BN/37/18/HH

PLAN-024737

Proposal: Annexe extension ancillary to main dwelling.
Site: Parsonage Farm House, Lake Lane, Barnham, PO22 0JD.
BN/37/18/HH

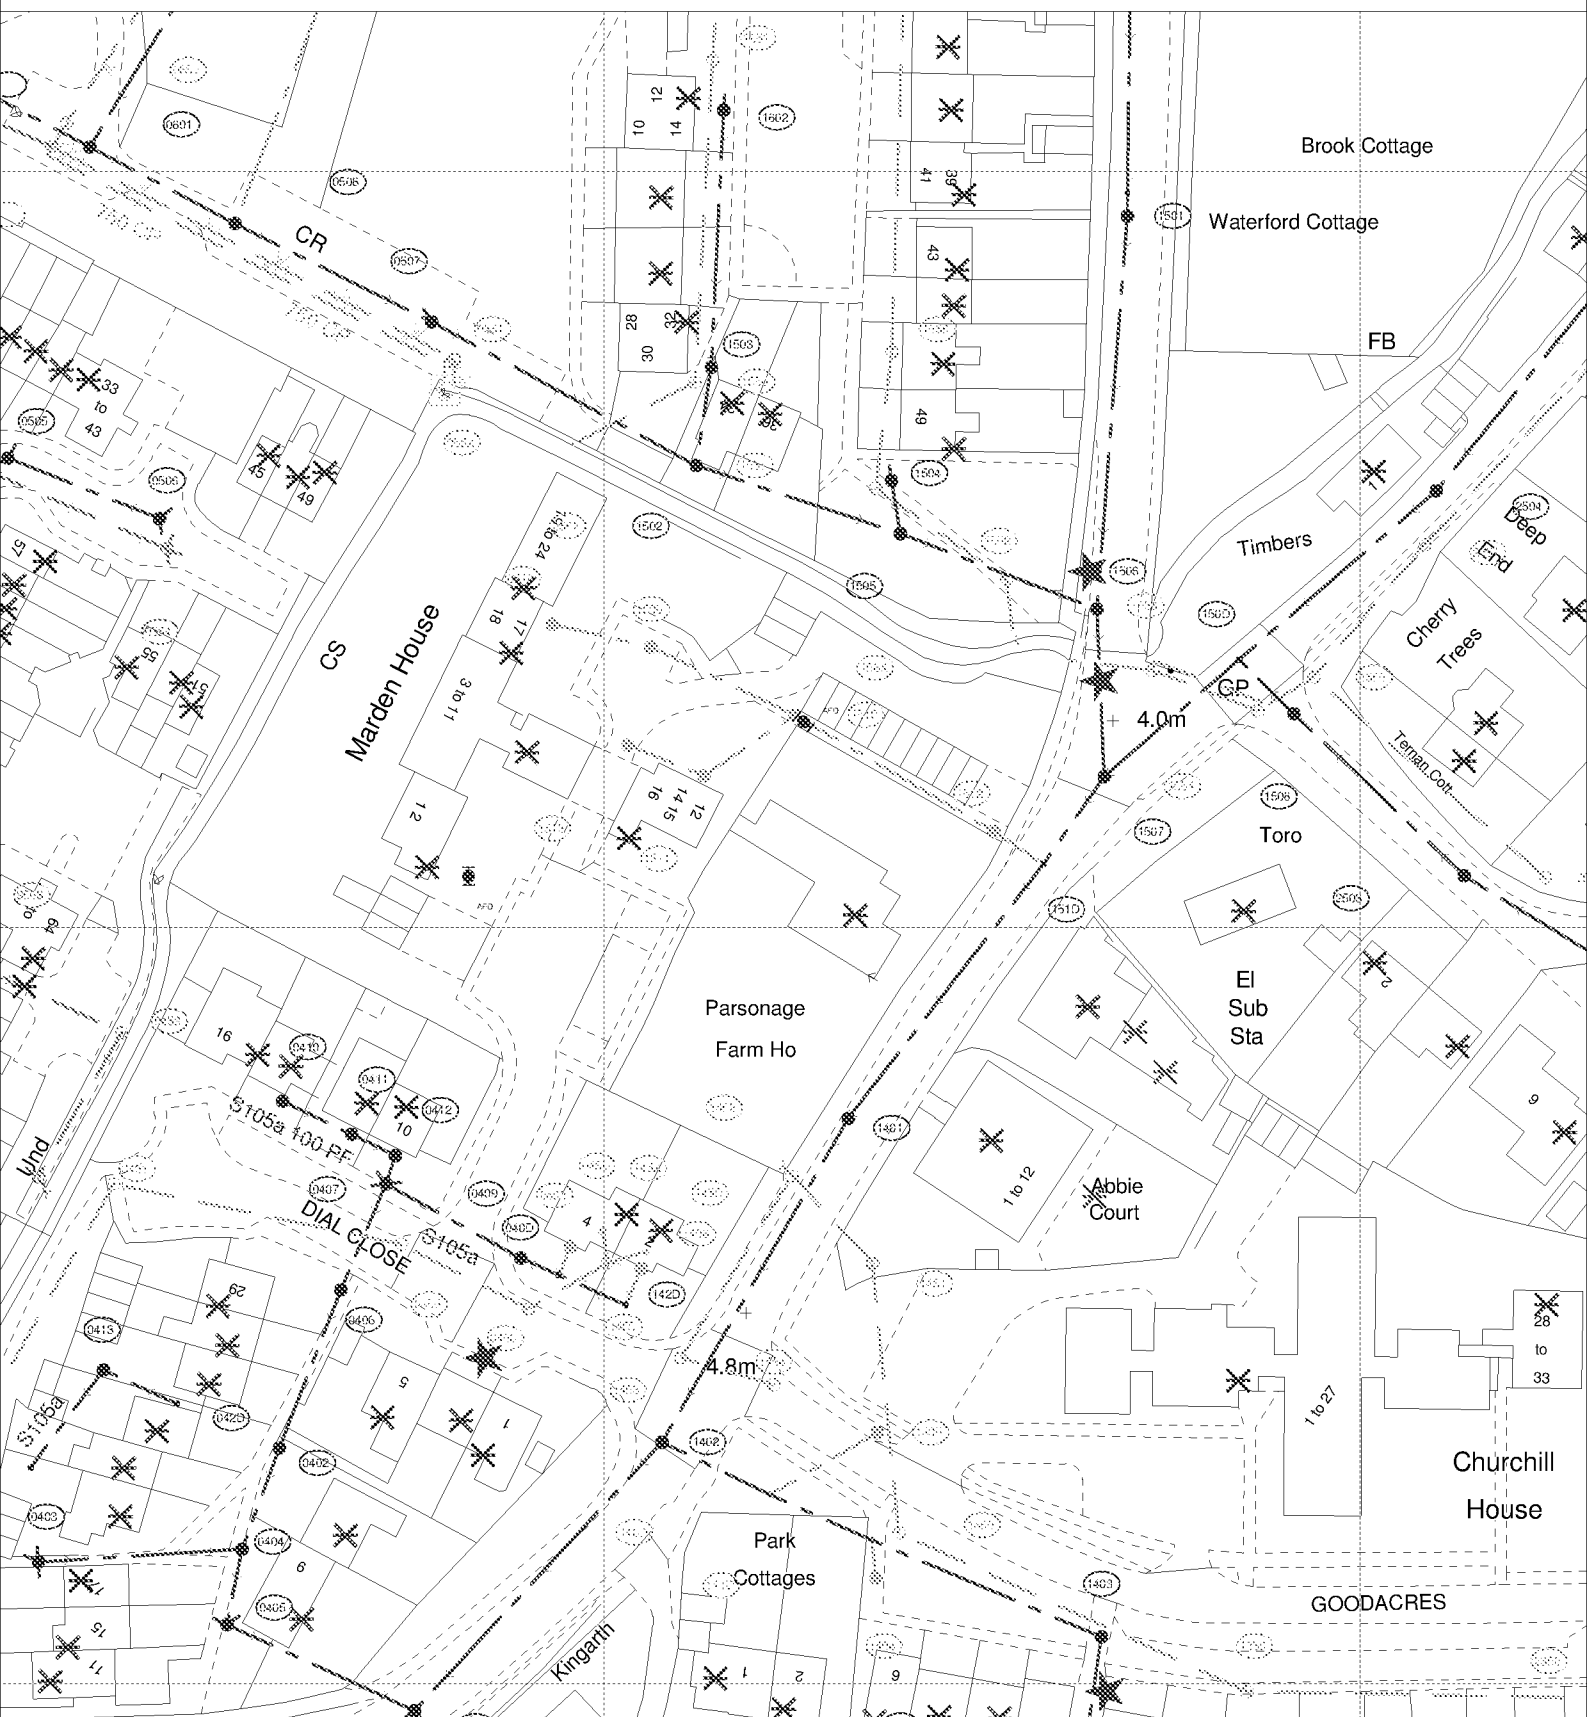
Due to surface water inundation issues in the Lidsey Catchment “The applicant is advised to adopt, where appropriate, the measures in the table “Practical measures to reduce the potential impacts of development”.

Developer should look to protect the public sewerage system from inundation and infiltration, which contribute to flooding in unfavourable conditions.
